CITY OF ONTARIO DEVELOPMENT ADVISORY BOARD

AGENDA

April 20, 2020

- B. ENVIRONMENTAL ASSESSMENT AND DEVELOPMENT PLAN REVIEW FOR FILE NO. PDEV19-014:** A Development Plan to construct a gasoline fueling station (Mobil) and 3,500 square foot convenience store on 0.97-acre of land located at the southwest corner of Philadelphia Street and Archibald Avenue, within the Support Commercial land use district of the Archibald Center Specific Plan. The project is categorically exempt from the requirements of the California Environmental Quality Act (CEQA) pursuant to Section 15332 (Class 32, In-Fill Development Projects) of the CEQA Guidelines. The proposed project is located within the Airport Influence Area of Ontario International Airport and was evaluated and found to be consistent with the policies and criteria of the Ontario International Airport Land Use Compatibility Plan (ALUCP); (APN: 1083-011-20). **Submitted by Atabak Youssefzadeh.**

Exhibit C—ELEVATIONS (Convenience Store)

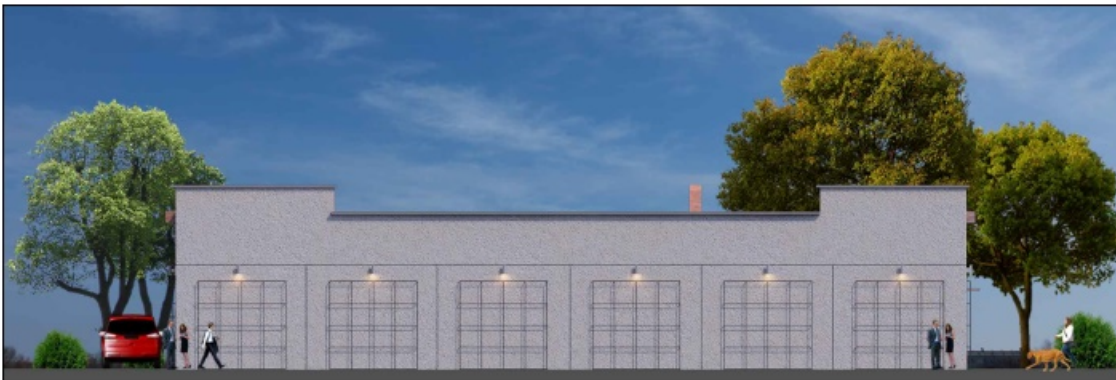
(a) Provide additional architectural elements such as, but not limited to, a cantilever canopy with tie backs and/or other horizontal elements to provide relief to the eastern elevation. The final exterior elevations shall be subject to review and approval by the Planning Director.

Exhibit F—LANDSCAPE PLAN

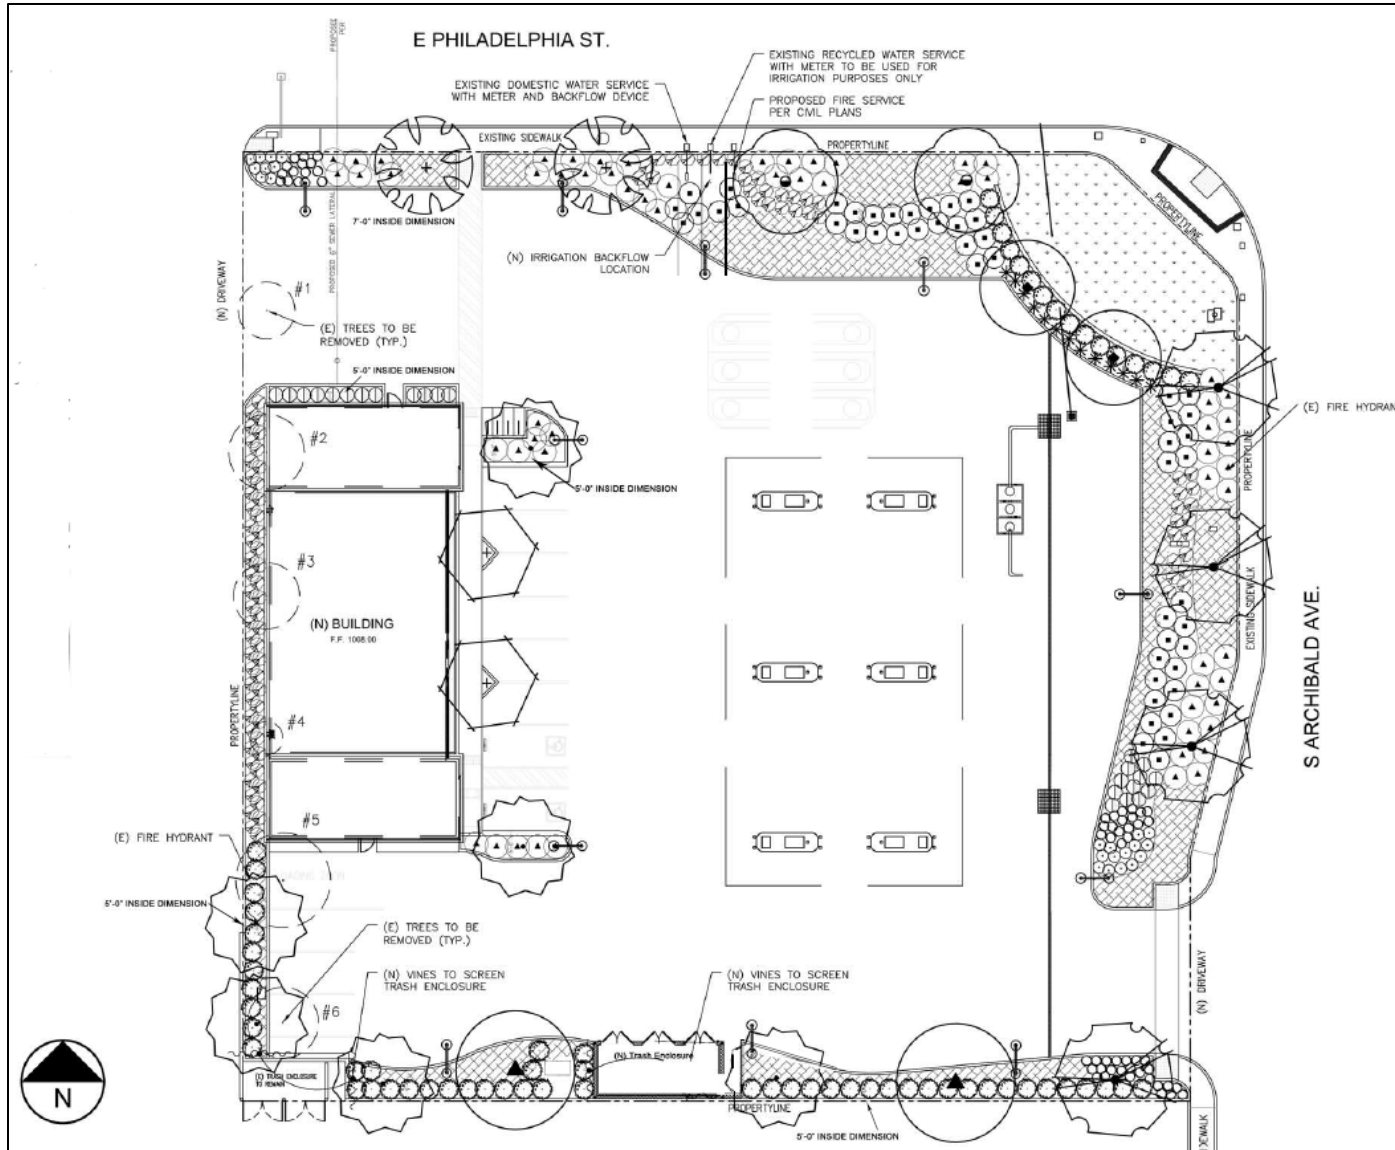
(e) Eliminate 3 parking spaces at entry; omit the diamond planters. Provide an entry walkway with 2 - 5' wide planter spaces with accent shrubs and groundcover with a 4' entry walkway in between. Increase the width of end island planters to 10' (Plant *Quercus ilex* or *virginiana*). See additional Landscape Division conditions attached.

(f) Provide a 5' landscape planter along the south side of the building, show foundation shrubs and groundcovers. Show any doors, if any, on the site plan, landscape plan and elevations that provide access from the adjacent loading zone. See Landscape Division conditions attached.

EXHIBIT A—Exterior Elevations Required Revisions

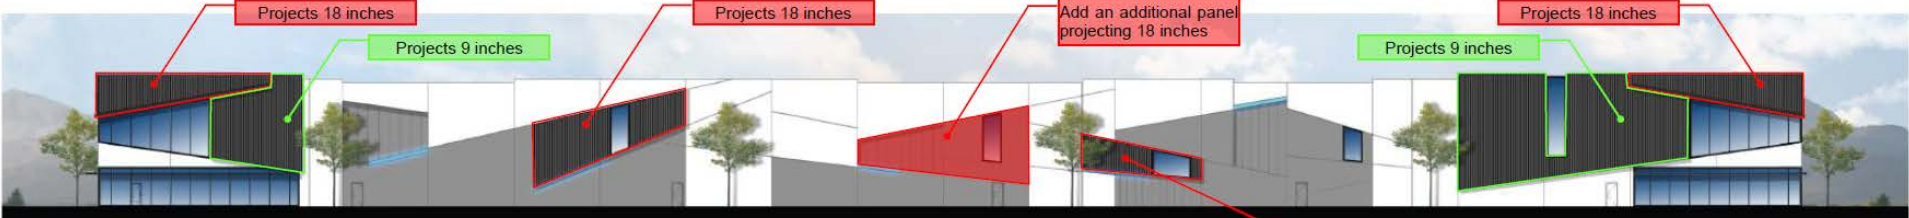
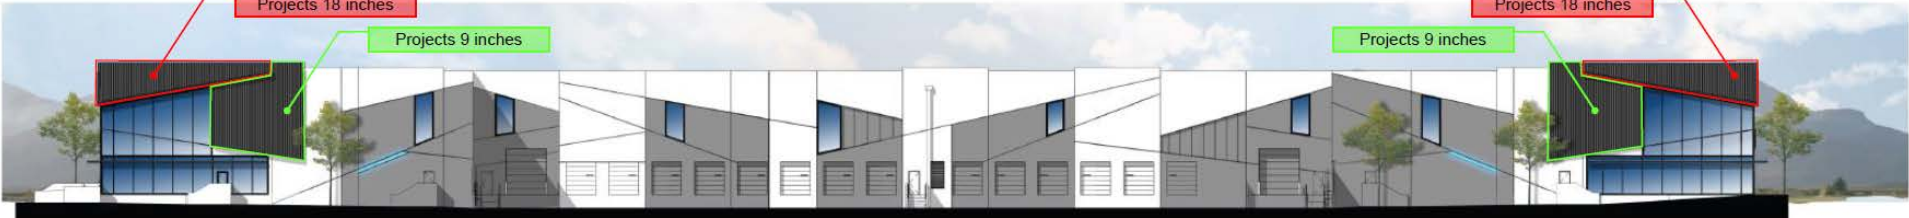
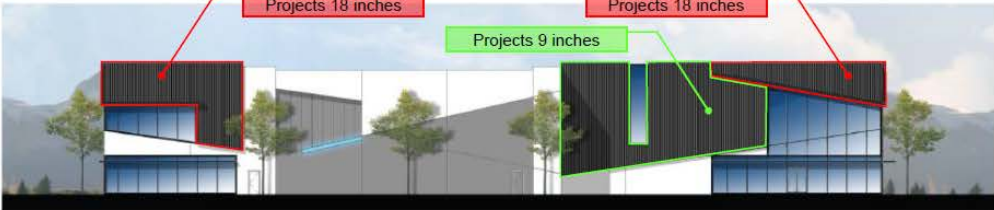
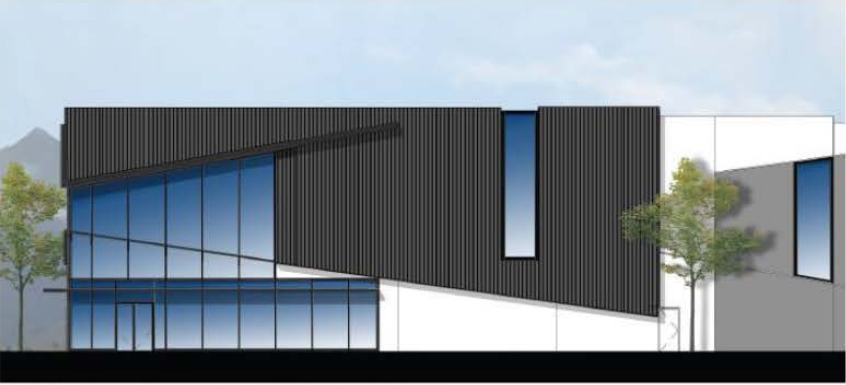
(c) The exterior building elevations shall be revised pursuant to Exhibit A (Exterior Elevations Required Revisions) of these Planning Department, Land Development Division, conditions of approval.

(d) The projecting metal siding shall be provided with a return to the building wall, so as to screen the open area between the concrete wall panels and the back of the metal siding panels.
